**Marion County
Board of County Commissioners**

**PLANNING & ZONING SECTION
STAFF REPORT**

P&ZC Date: 11/28/2022	BCC Date: 12/20/2022
Case Number:	221211ZP
CDP-AR:	29235
Type of Case:	Rezoning from Planned Unit Development (PUD) to Planned Unit Development (PUD)
Owner	New Times Development, LLC
Applicant	Tillman and Associates Engineering, LLC
Street Address	7562 W HWY 318
Parcel Number	03165-001-00
Property Size	41.29 acres
Future Land Use	Employment Center (EC)
Zoning Classification	Planned Unit Development (PUD)
Overlay Zone/Scenic Area	Farmland Preservation Area and Secondary Springs Protection Zone
Staff Recommendation	APPROVAL WITH CONDITIONS
P&ZC Recommendation	APPROVAL (On Consent)
Project Planner	Kenneth Weyrauch, Sr. Planner
Related Case(s)	Existing PUD 200506Z

**FIGURE 2
CONCEPTUAL PLAN**

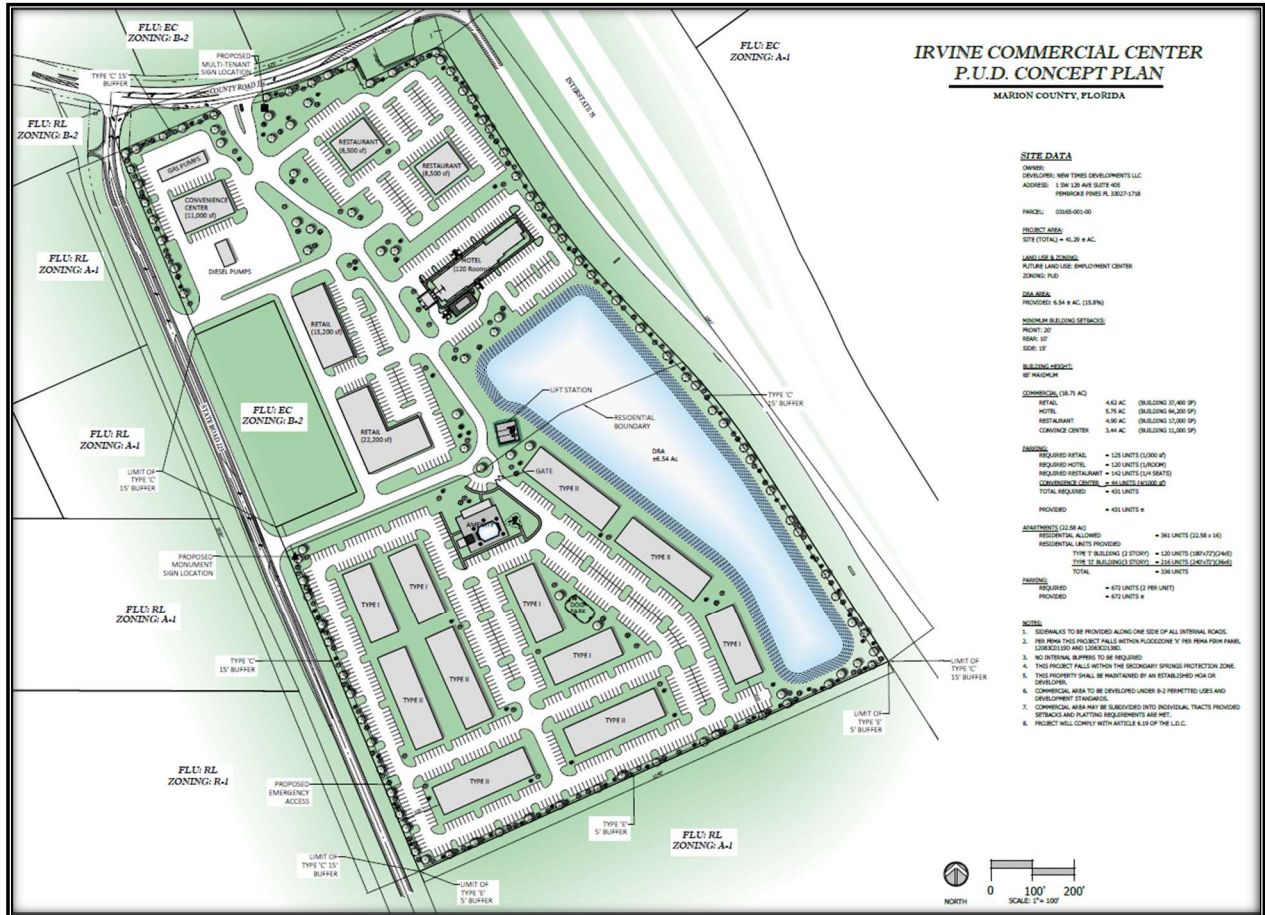
Analysis: Staff finds that the PUD proposes three access points. The northern access point is on HWY 318, and two access points to the west on NW HWY 225. The proposes uses within the limitations of the Employment Center Land Use Designation.

Analysis: Buffer details are proposed within the application (see Attachment A, Page A-3 and A-4). Staff finds that the PUD is proposing a C-type buffer (15' wide landscape strip without a buffer wall. At least 2 shade trees and 3 accent/ornamental trees for every 100 lineal feet or fraction thereof) along the right-of-way HWY 318, HWY 225, and Interstate 75, which is consistent with the LDC. The PUD also proposes a Type E buffer (5' wide landscape stripe without a buffer wall. At least 4 shade trees for every 100 lineal feet or fraction thereof). The LDC required buffer along the right of ways be a Type C buffer, however, the existing approved PUD is required to provide for gateway buffers along HWY 318 and HWY 225 to provide for a visually enhanced scenic view. The existing PUD is also required to provide a larger buffer adjacent to the Interstate. The only difference between the existing PUD and the proposed PUD is the proposed PUD has multifamily adjacent to the agricultural land to the south. While the PUD proposes a Type E buffer as required in the LDC, staff recommends an enhanced buffer due to this location being inside the Farmland Preservation Area. Internally, the PUD does not propose a buffer. Typically, if commercial develops adjacent to multifamily the commercial development is required to provide a Type B Buffer (20' wide with a wall), and the multifamily developing adjacent to commercial land is required to provide a Type A buffer (30' wide without a wall). The normal total buffer area is 50' between the two uses. Since there is an internal road separating the commercial and residential area of the PUD, staff recommends a Type C buffer between these uses to provide a landscaped and treed area as a visual and physical transition between the two areas of the PUD. Notwithstanding, staff recommends the following condition be imposed:

Analysis: Access to the property is shown on the conceptual plan. There are three access points to paved public roads, and all roads within the PUD will be paved. The PUD proposes one access to HWY 318 and two accesses to HWY 225. There are several operational issues concerning access points within this location, especially due to other approved PUDs nearby. The Traffic Department within the Office of the County Engineer (OCE-Traffic) writes, "There are operational concerns with the type and location of driveways presented on the concept plan. The full access to CR 318 is too close to the existing intersection of with CR 225. The traffic created by this development along with the other recently approved developments of Jockey Club and Sunny Oaks may possibly create a need for a traffic signal at CR 318 and CR 225. This will likely require a longer westbound left turn at CR 225 and the proposed turn lane into this development will take up that needed space. There are also safety concerns with have an additional full access with the curve. It is recommended that the access onto CR 318 is limited to a right-in/right-out only and that access management features like a raised concrete traffic separator be placed on CR 318 to limit access. There is an old service station at the northeast corner of the property near the southbound on-ramp for I-75. It has two driveway connections to CR 318. Both driveways will need to be closed off.

There is also a concern with the two proposed full access points on CR 225. Neither one of them meets the spacing requirements for full access. It is recommended that the southernmost driveway be a full access while the northernmost driveway is limited access as determined in the traffic study.

The northern most driveway will also need coordination with the proposed driveway with the Jockey Club which has not been shown on the concept plan.” And “both CR 318 and CR 225 have limited right-of-way. A right-of-way dedication will be required along each of the roads to provide for the proposed roadway improvements. The needed right-of-way on CR 318 is 27 feet while the needed right-of-way on CR 225 is 10 feet. This dedication needs to be noted on the master plan.” Notwithstanding, staff recommends the following condition be imposed:

Analysis: Staff finds PUD proposes sidewalks along the adjacent right-of-ways and on at least one side of all internal roads. However, multi-modal circulation is not shown within the conceptual plan. Staff has provided recommendations, above, to address these issues. The proposed PUD **is inconsistent with this section.**

Analysis: Staff finds that a typical illustration and table have been provided for the main structures but no height indication is provided on the illustration. No illustrations have been provided for the accessory structures, recreational uses, or commercial uses. Thus, as conditions of approval:

- Buffers along HWY 318 and HWY 225 shall be a 20-foot landscape buffer and shall include landscape plantings on a berm, which shall not be less than two feet in height, and a three-board wood fence. The fence is to be black, white, or neutral earth-tone in color. A minimum of two shade trees and three ornamental trees for every 100 lineal feet or fraction thereof shall be provided in the buffer. Shrubs and groundcover shall be provided to create a layered visual effect. A Type A buffer shall be placed along the eastern and southern boundaries.
- A Type C buffer shall be placed, on the southern side of the road, between the commercial and multifamily areas. The buffer shall allow for pedestrian access from the multifamily to the commercial retail area.

- At least two weeks before the Board of County Commissioners Adoption Hearing, the project’s Traffic Study shall be completed to the satisfaction of the County Engineer and Growth Services Director, adequate provision shall be made for the coordination of improvements with the PUD and submitted for staff review.

- All uses within the PUD shall access streets internal to the PUD, no direct access to HWY 318 or HWY 225.
 - The PUD shall have no more than one access connection to HWY 318 and no more than two access connections to HWY 225.

- The access onto HWY 318 shall be limited to a right-in/right-out only. Access management features, such as a raised concrete traffic separator to be placed on HWY 318 to limit access. The service station at the northeast corner of the property near the southbound on-ramp for I-75. It has two driveway connections to HWY 318. Both driveways will need to be closed off.

- At least 14 days before the Board of County Commissioners Public Hearing, the conceptual plan shall be amended to provide a typical illustration and table showing the maximum height of all residential and non-commercial structures.
